Ray
8035 STARVED ROCK LANE
Payton CO 80831

Planning Comments [Review 1]

Site Plan _V1.pdf Markup Summary

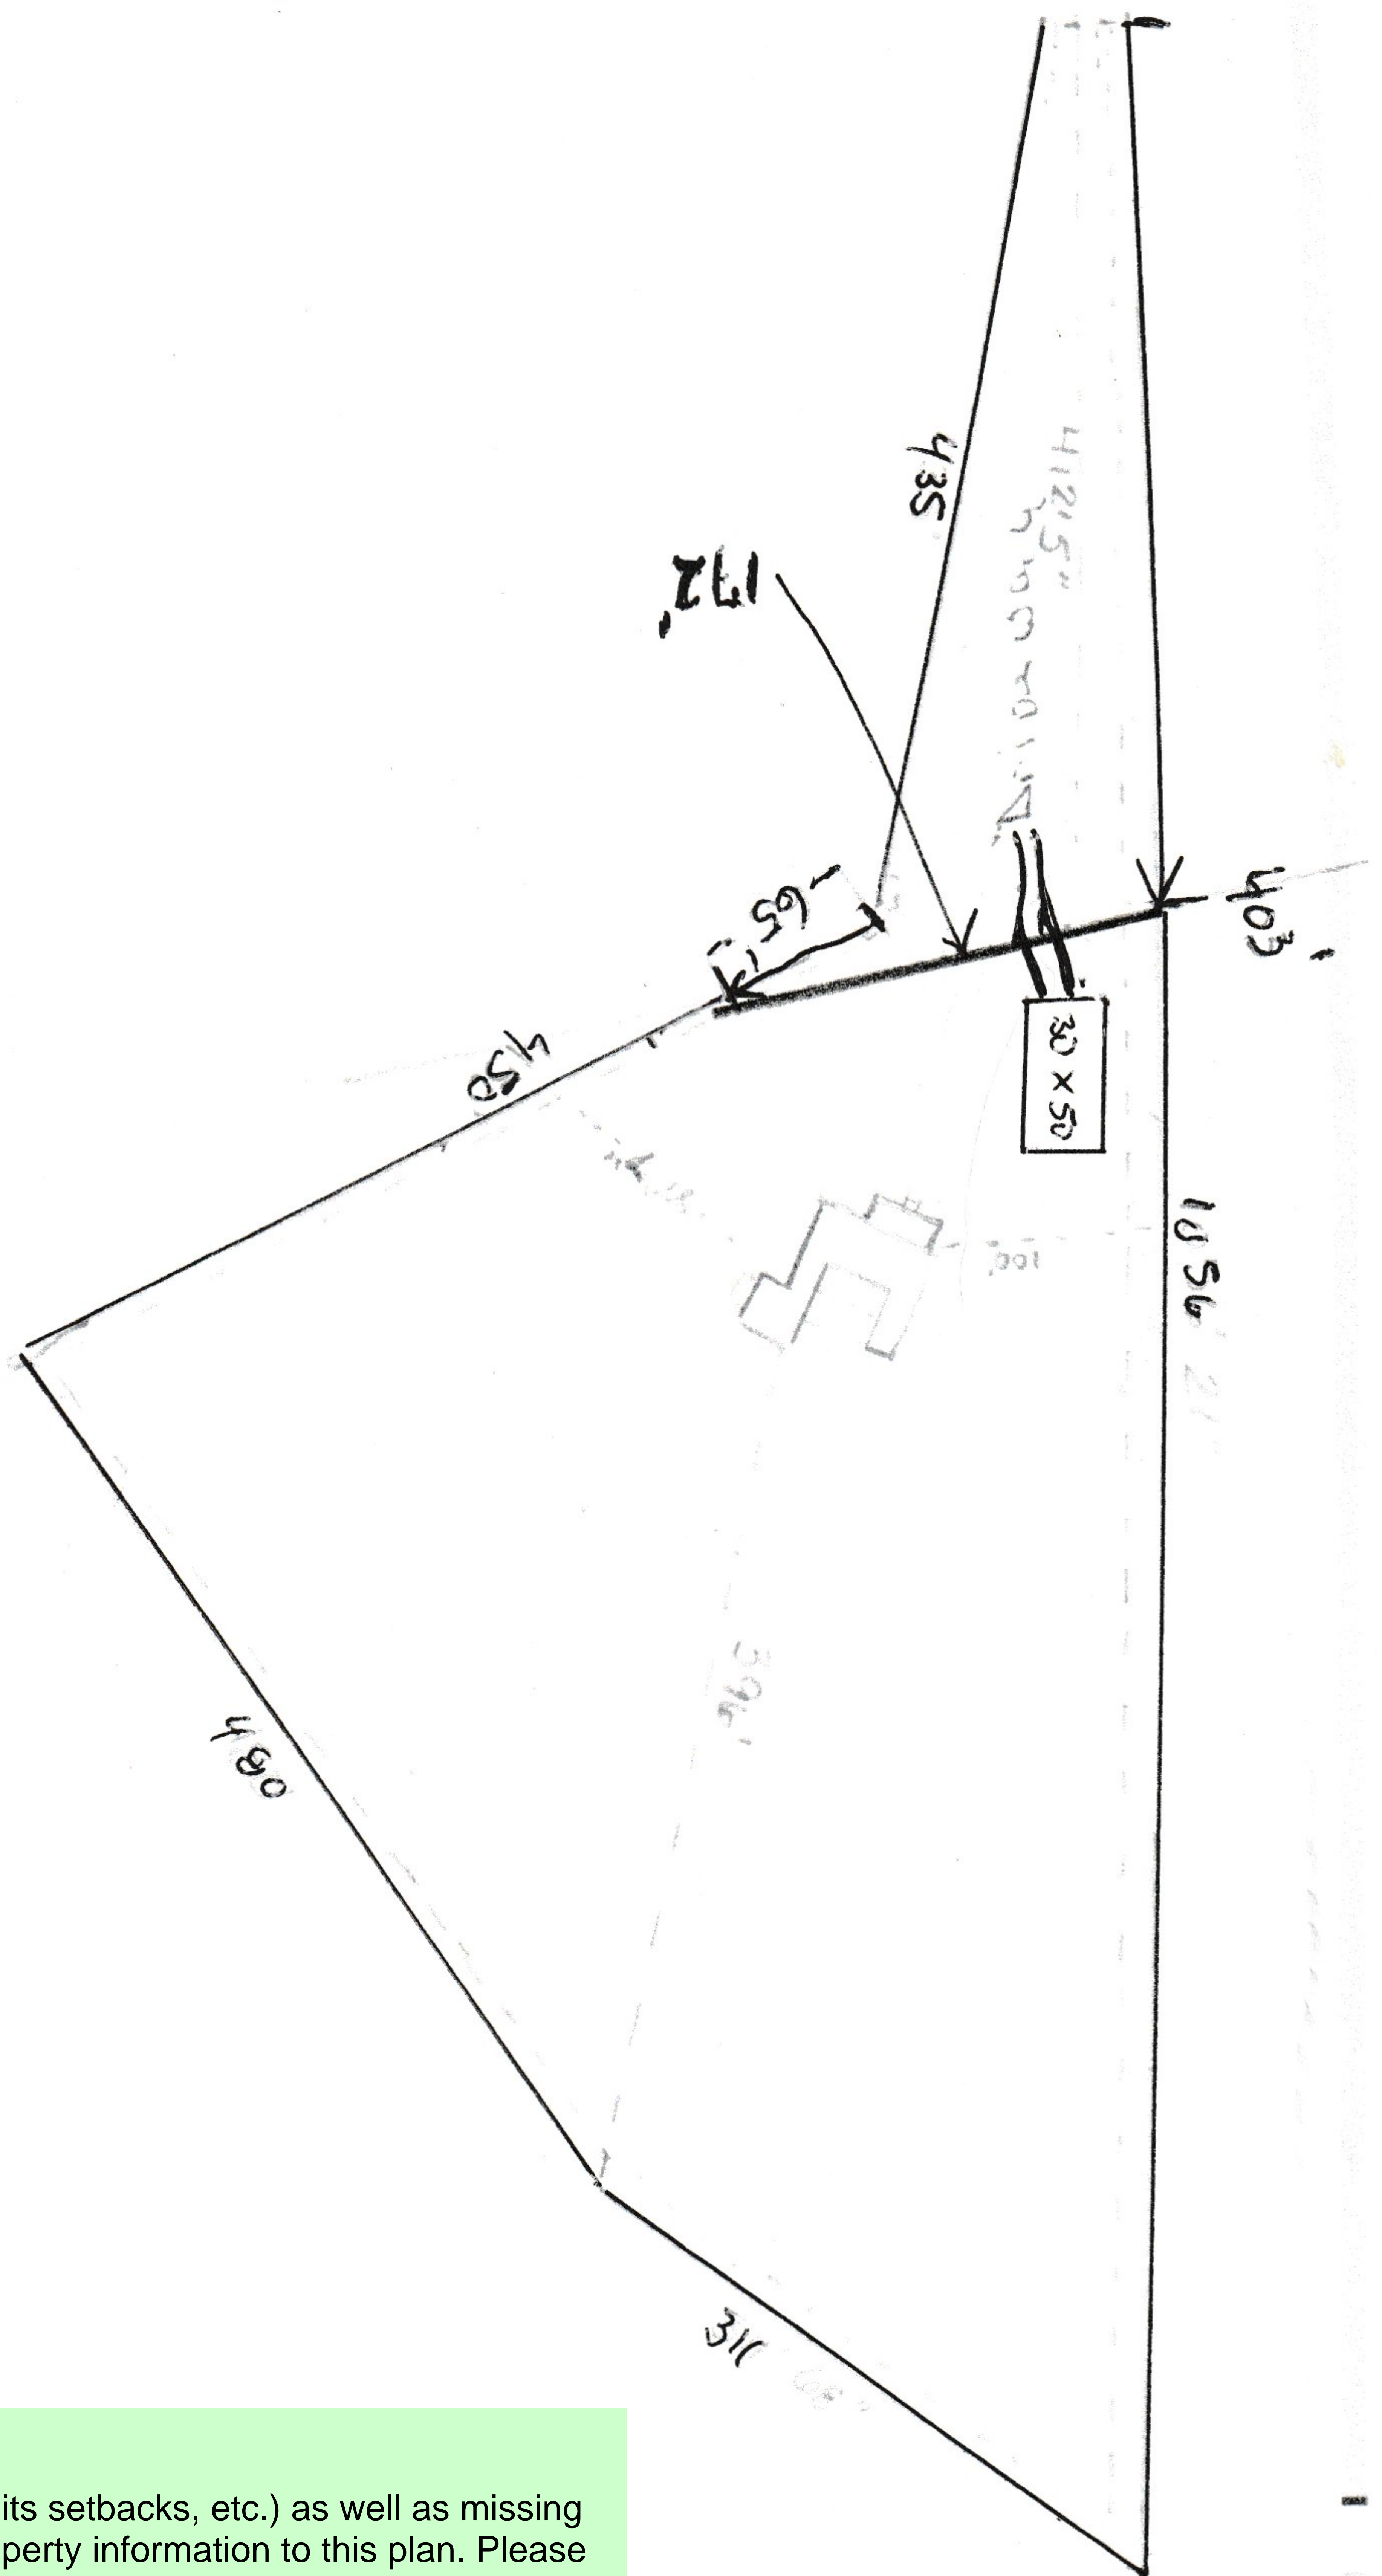
-Some of this plan is illegible (ink is too faint for house and its setbacks, etc.) as well as missing required information. Please add required site plan and property information to this plan. Please refer to the example site plan on our "site plan questions" web page via the below link. Please be sure to include everything that's noted on the example (scale, property parcel ID, lot coverage, clearly show **all** buildings (proposed and existing) and setbacks from **all** buildings to **all** property lines, street name where cul de sac meets property, zoning designation, etc.). There's also a Q&A for "what's required on a site plan".

-Please note that the proposed barn must also meet the 25-foot side setback requirement. The side setback from the proposed barn is not shown, so I'm unable to verify compliance in this review.
